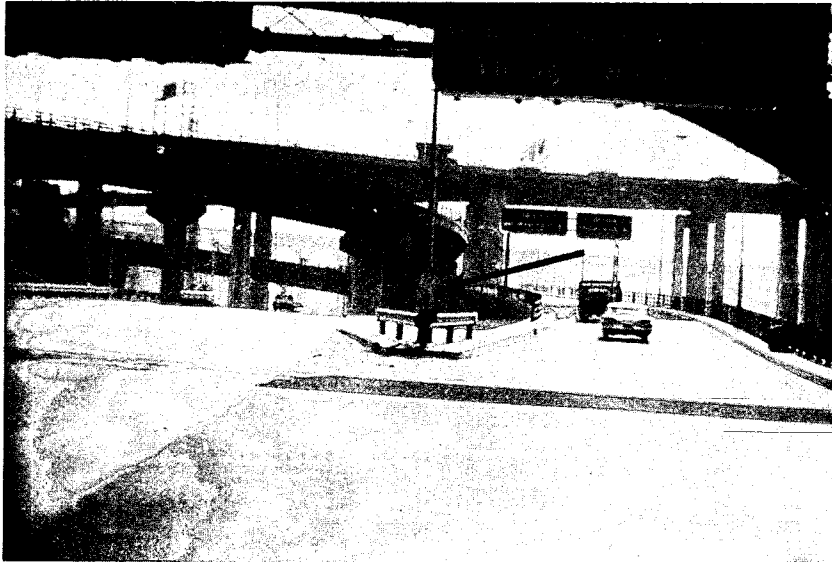
Here you see they spanned the gore area with the sign and had to go and put a little light bulb there. Once you put a little bulb there, you have got to have 40 feet of guardrail to protect the light.

They have money for this guardrail at this point, but I feel they should use it where it is really needed.

Mr. MAY. Any particular reason why they should put a guardrail in front of a breakaway light pole?

Mr. MAY. This is another example of the waste of money and the creation of a hazard.

Mr. BLATNIK. A breakaway light pole would not do any good if you have a concrete obstacle like this?

Mr. BLATNIK. Why do they have a big block of concrete there? If that concrete base were flush with the ground you could still bolt the light post to it.

Mr. PRISK. No. Experience and research have shown that short sections of guardrail at light standards are more hazardous than an unprotected light pole.

Mr. PRISK. I was basing my statement on the breakaway type pole, which would break it at the ground level.

Mr. PRISK. Some of this is consideration of vertical clearance to the bottom edge of the sign. This is rather carefully controlled, so as to provide clearance consistent with the clearance of structures. The pole is ordered in a given standard length, such as is commonly manufactured in quantity. If this is shorter than what is required, the concrete is built up high enough to reach the bottom of the pole and to obtain the proper vertical clearance. There is no real reason why a somewhat longer pole could not be ordered at a slight additional expense, and that footing could then be flush. You might have a slight excess of vertical clearance under the sign.
